City of Santa Fe
Historic Districts Review Board
Findings of Fact and Conclusions of Law

Case #H-18-115

Address – 210 Don Gaspar

DATE: October 9, 2018
TO: Historic Districts Review Board Members
VIA: Nicole Ramirez Thomas, Acting Historic Preservation Supervisor
FROM: Carlos Gemora, Land Use Planner

EXISTING & PROPOSED
 WEST ELEVATION
 SEPTEMBER 11, 2018
 SCALE: 1/8" = 1'-0"

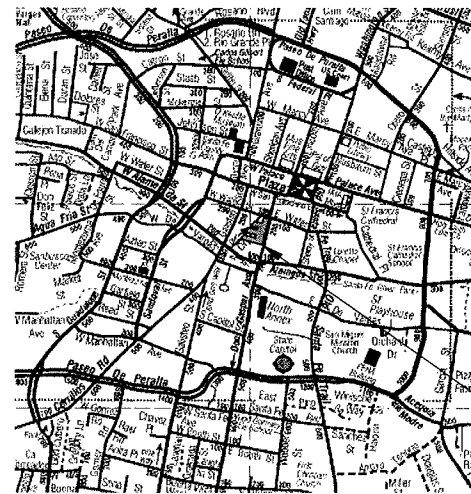
15. The proposed configuration and height of parapet and trellis are awkward.
16. Lowering the parapet height and trellis by one foot each would be more harmonious to the building and streetscape.

X Additional conditions, which are: that height the proposed parapet be lowered by 1 foot, and that the height of the trellis be lowered by 1 foot.

EXISTING &
PROPOSED
NORTH &
SOUTH
COURTYARD
ELEVATIONS

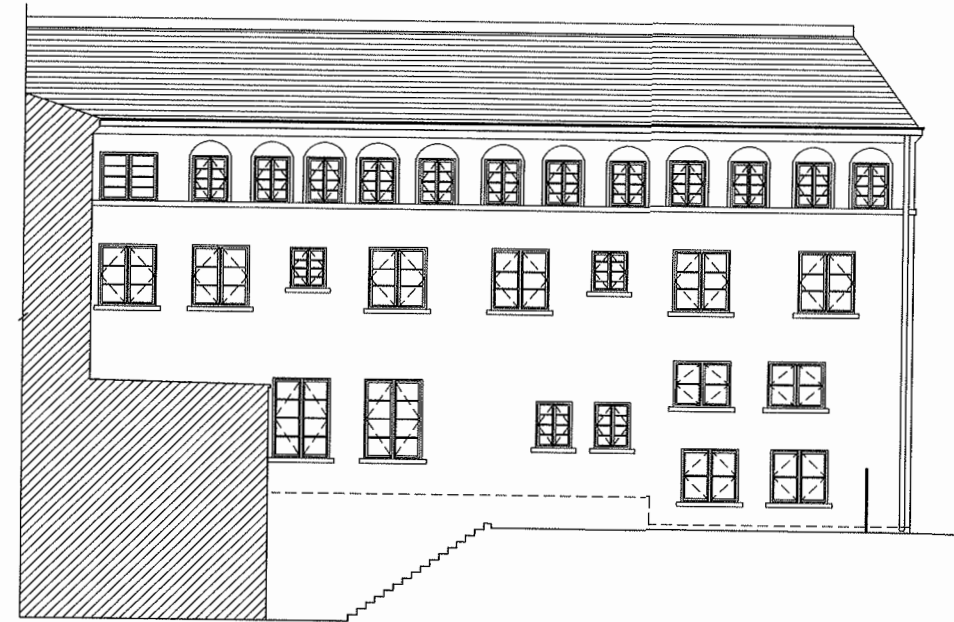
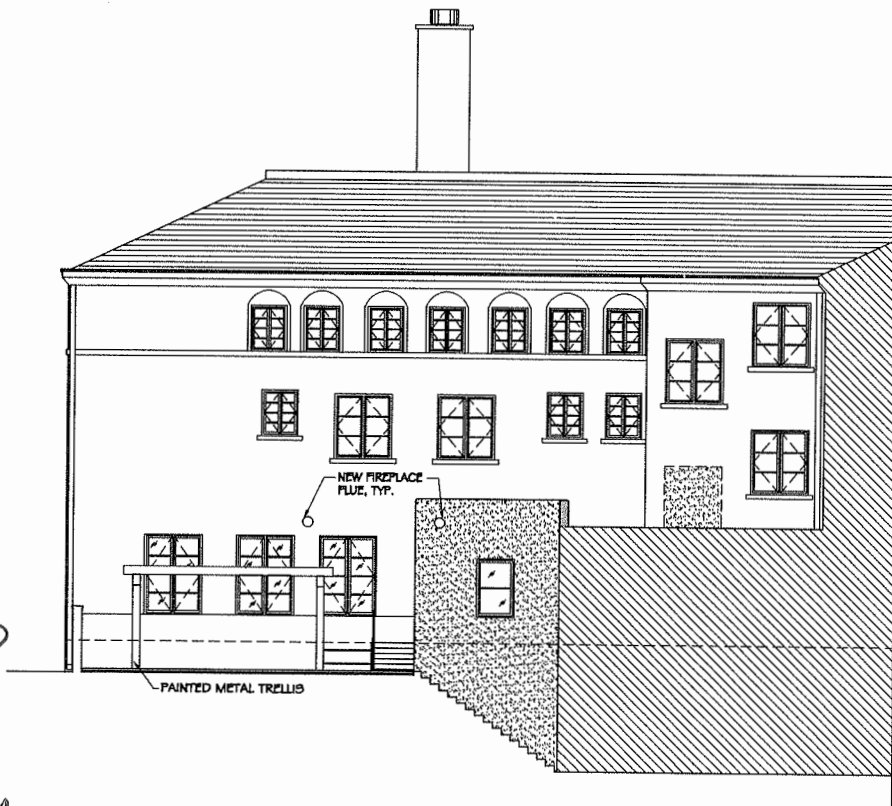
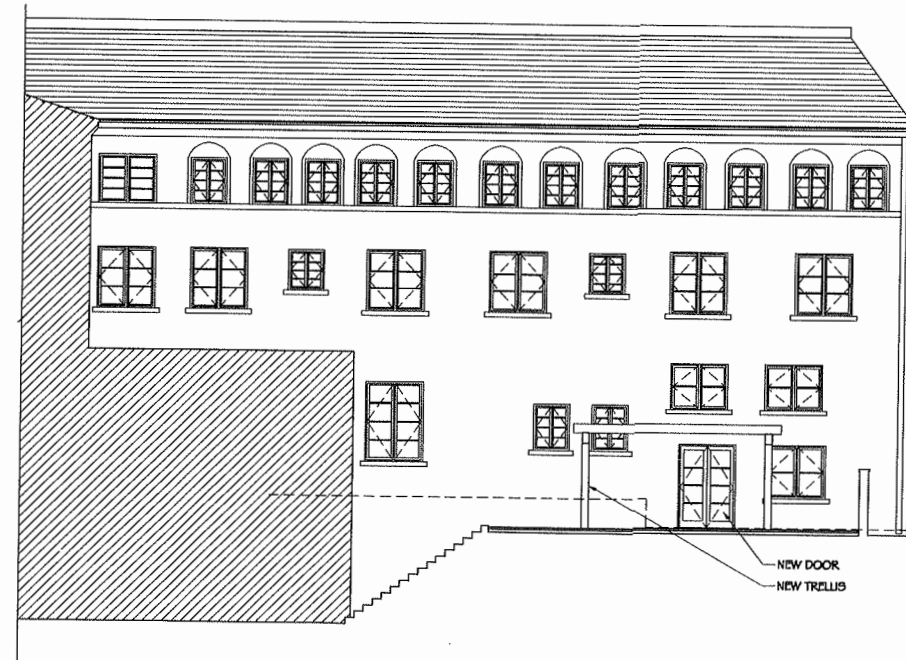
Staff Response: Staff disagrees with this statement. Reconstructing a relatively unusable raised garden area can be considered a unique or peculiar feature the applicant seeks to fix, but adding the "relaxation room" into the courtyard does not seem to be due to any special circumstance.

Staff Response: Staff disagrees with this statement. While creating hallways or access to the courtyard may be important, the applicant has not demonstrated that the height and mass of the additional room are minimized.

3 OVERALL PROPOSED EAST ELEVATION W/ WALL
A-3.1 SCALE: 1/8" = 1'-0"

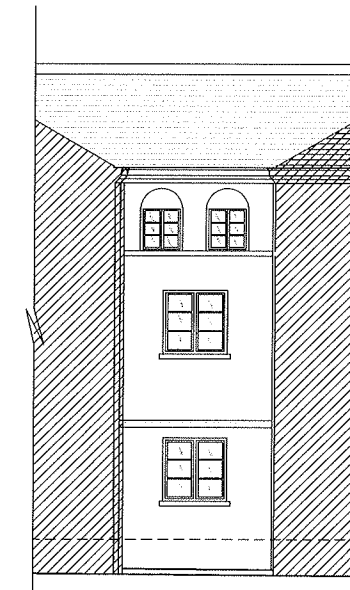
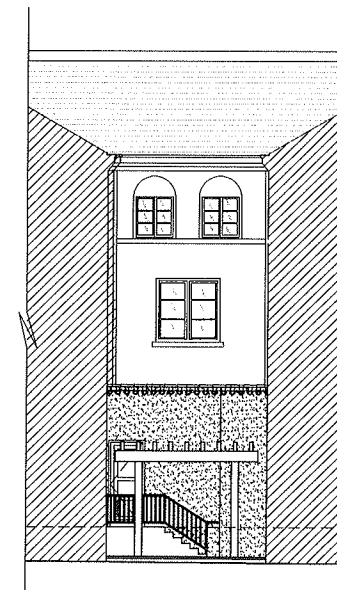
Staff Response: Staff agrees with this response. A 72" wall is likely to enhance rather than detract from the existing streetscape compared to the 72" existing fence.

Staff Response: Staff disagrees with this statement in not recognizing how a wall will be more stable for the courtyard exit. Staff recognize, however, that improving or maintaining the aesthetics of the streetscape can constitute a hardship and that a wall would likely be more harmonious than the existing fence.

Staff Response: Staff does not find the applicant's response demonstrates why wall height is connected to a special condition or circumstance.
